# Tolerance of fuel storage volume

the technical data to support the Japanese comment at 10<sup>th</sup> EPPR IWG on the tolerance of fuel storage

## The correlation between the fuel storage volume and evaporative emission

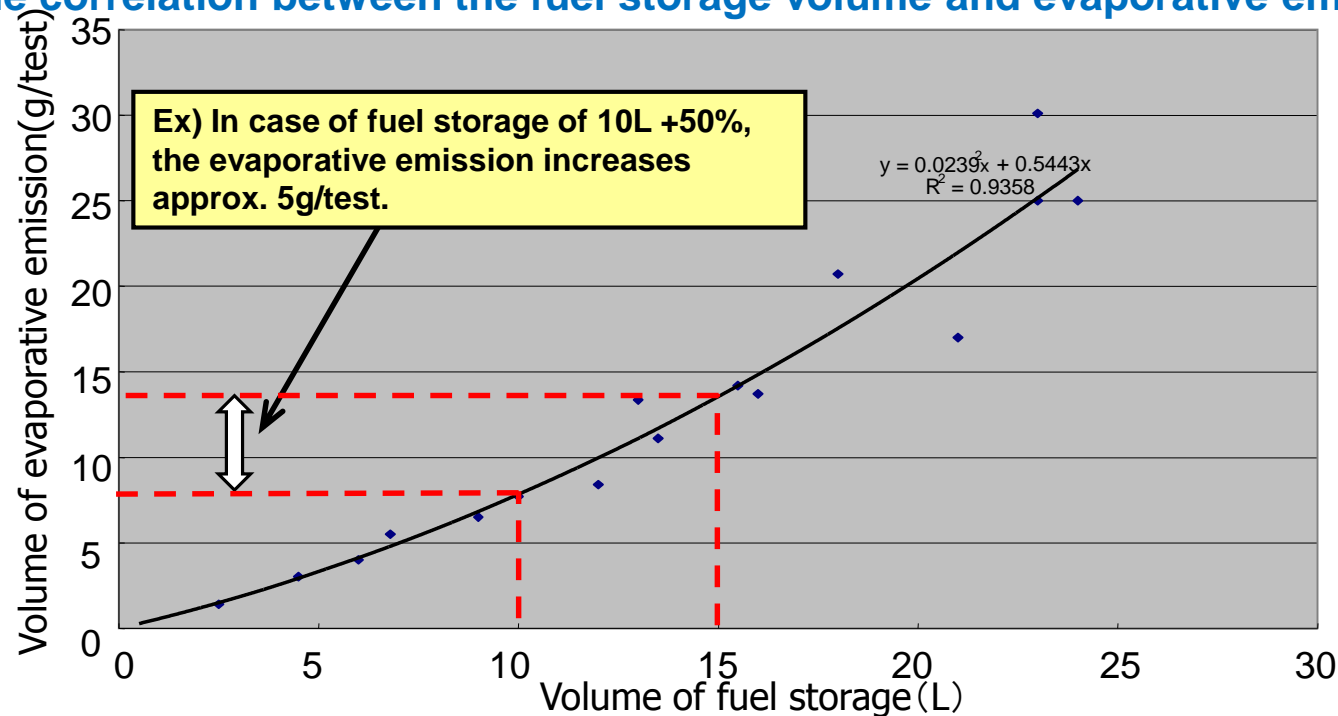
**Japan position: It is appropriate to allow only the smaller fuel storages as fuel storage family for the evaporative emission regulation.**

- There is a large correlation between the volume of fuel storage and of evaporative emission. It is obvious that evaporative emission increases as the fuel storage becomes larger.
- Therefore, it is impossible to judge whether a larger fuel storage meets the requirements without another evaporative emission test.

- ◆ The graph below shows the correlation b/w the volume of fuel storage and of the evaporative emission when tested under CARB test method without canister. (n=16)
